**Sycamore St. Lift Station and Forcemain Replacement  
Somonauk, IL**

**ADDENDUM NO.1**  
February 22, 2023

To clarify information, it is necessary to provide the following Bid Addendum No.1 for the above referenced project. Bid Addendum No.1 consists of revised specifications and plan sheets.

### W.W.T.P. PROPERTY PLAN AND PROFILE - PROPOSED FORCE MAIN OPEN CUT (BASE BID)

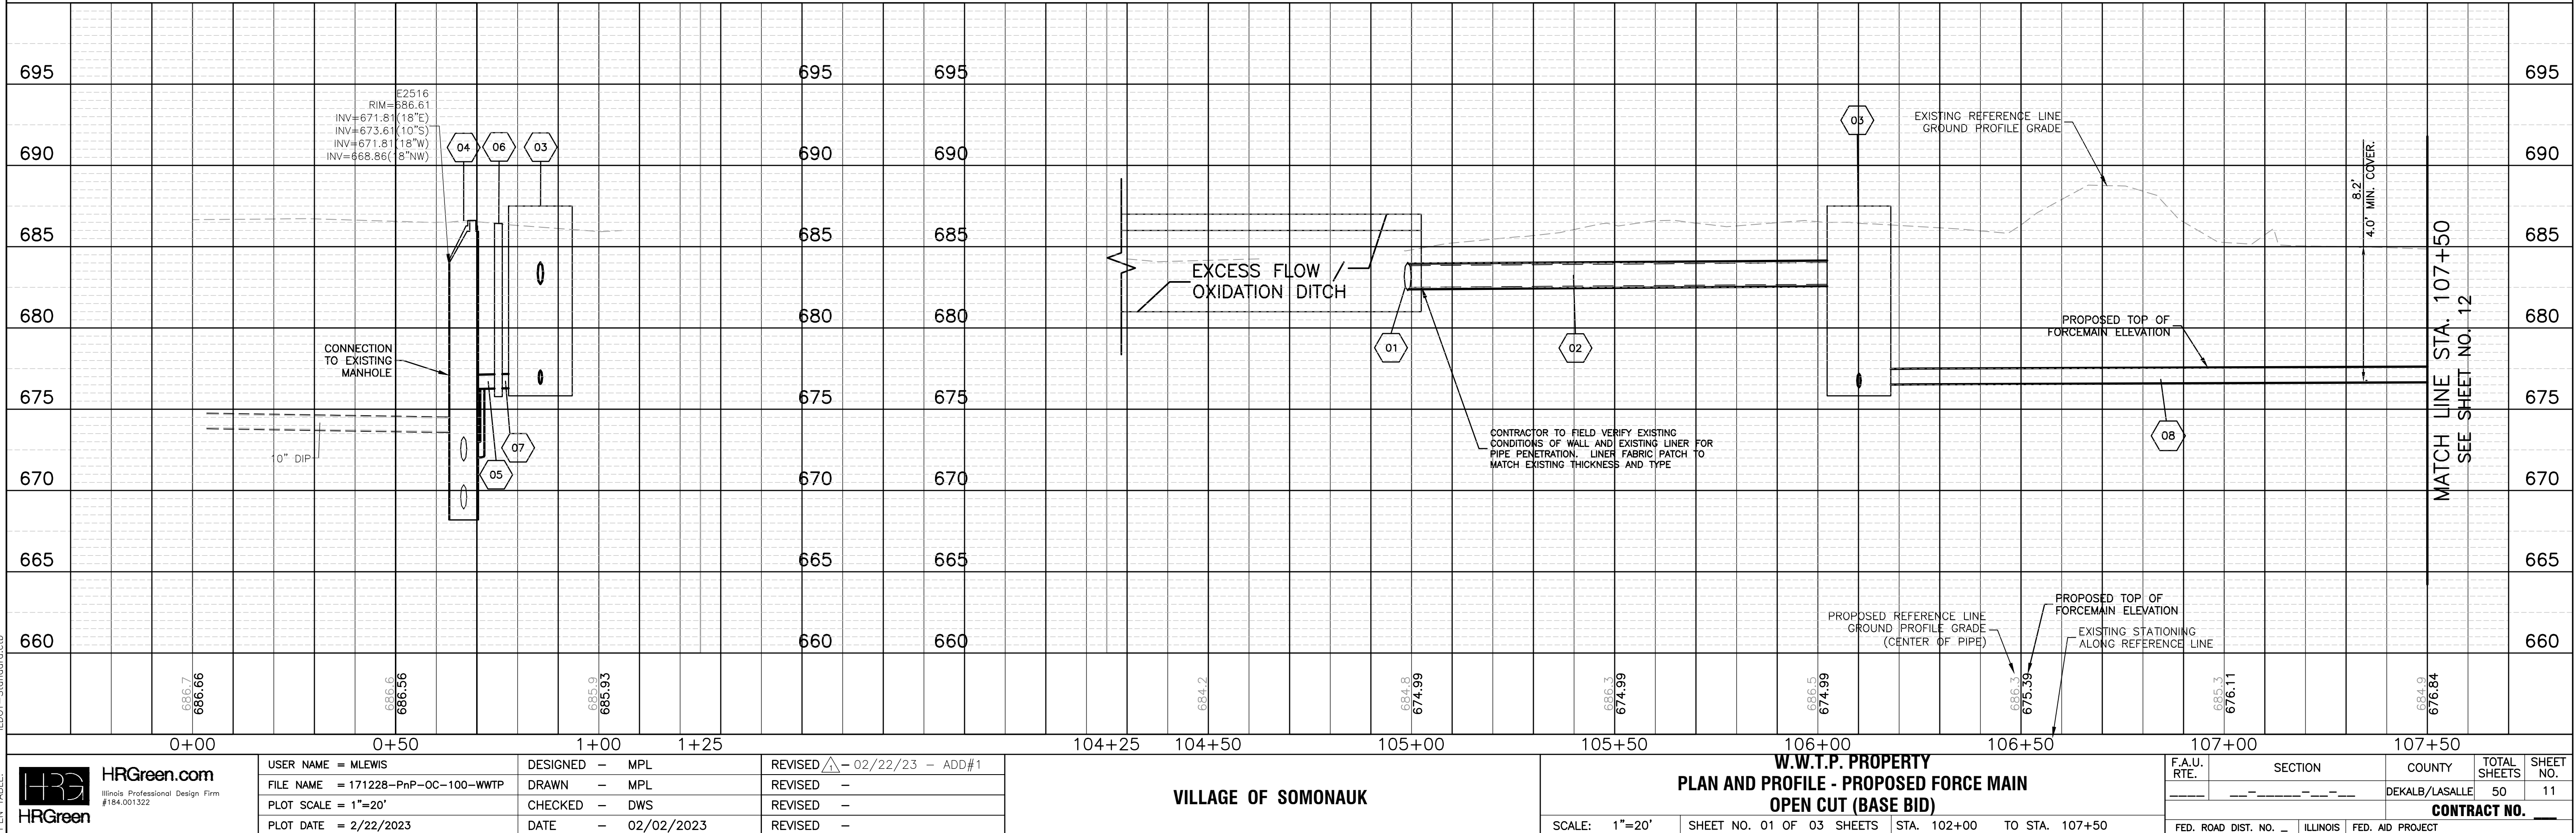
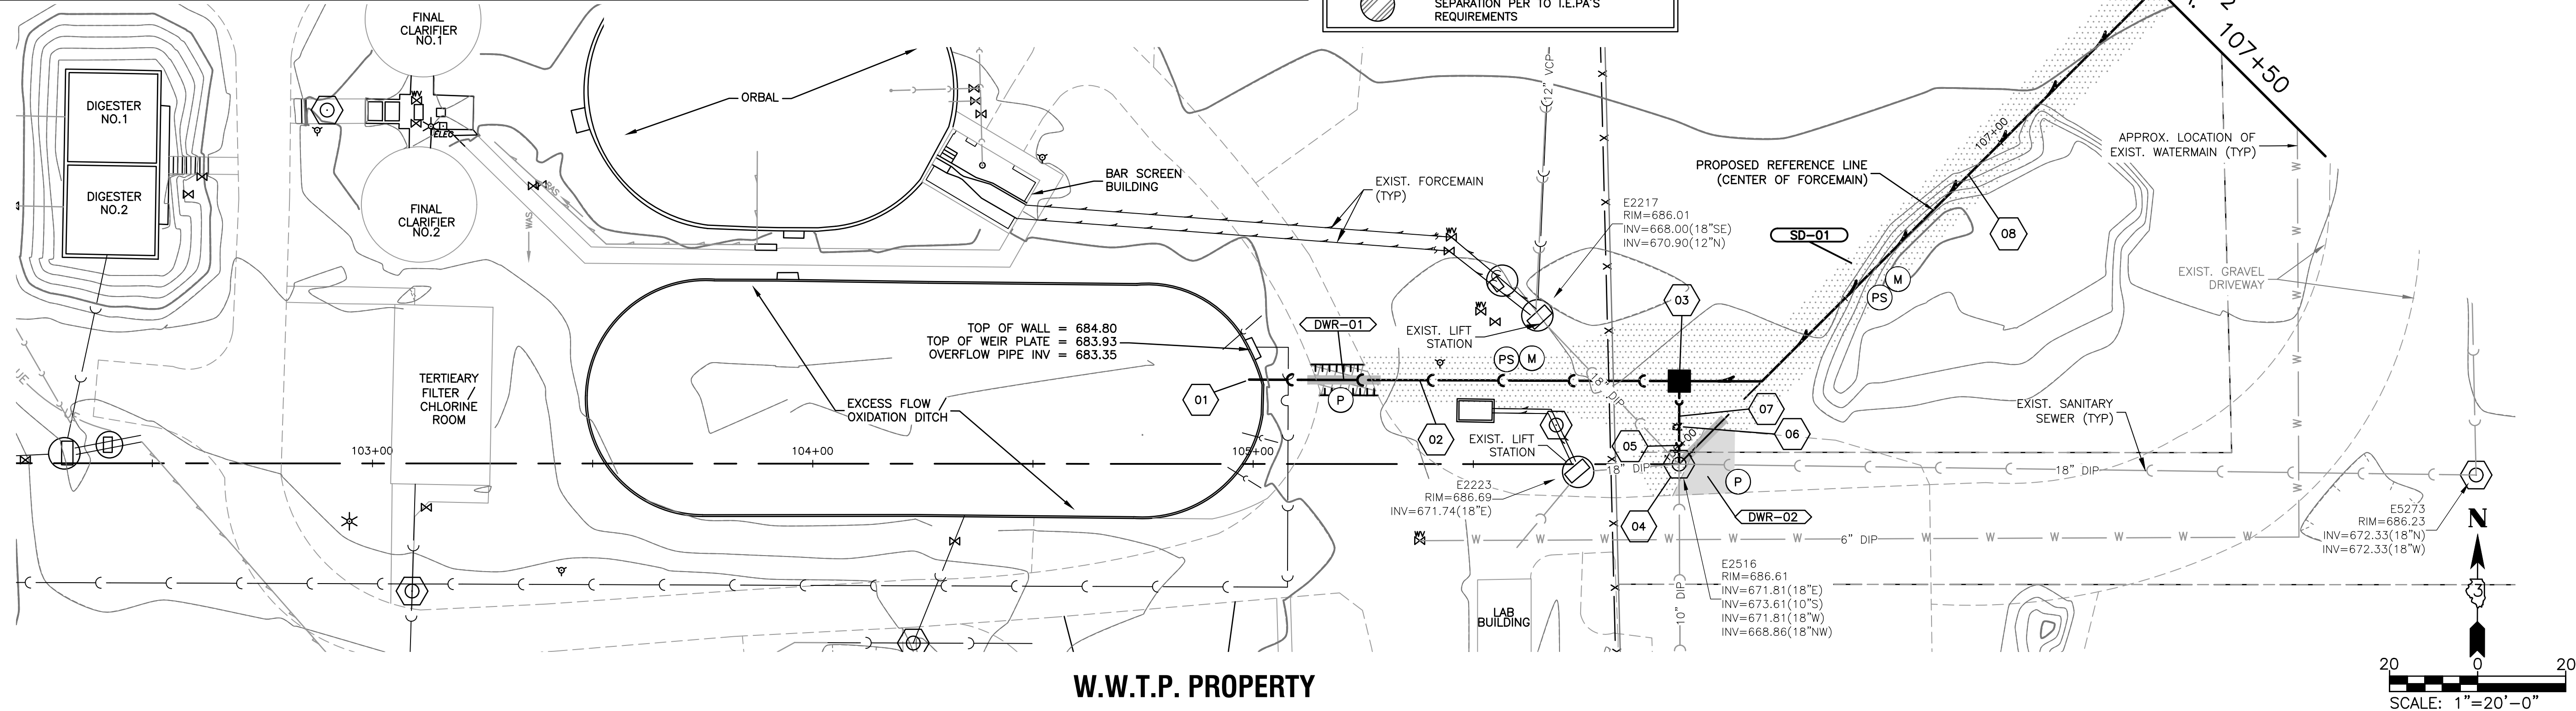
- b. Remove line 31 from the base bid summary of quantities and remove line 27 from the alternate bid summary of quantities. This removes Landscaping, Special from the project.
  - c. Revise/Update line 47 in the base bid summary of quantities and line 42 in the alternative bid summary of quantities to change the depth of Class D patch to 4" from 3".
2. Refer to Revised Plan Sheets 02, 11, 13-19, and 21-26 based on above revised pay items.
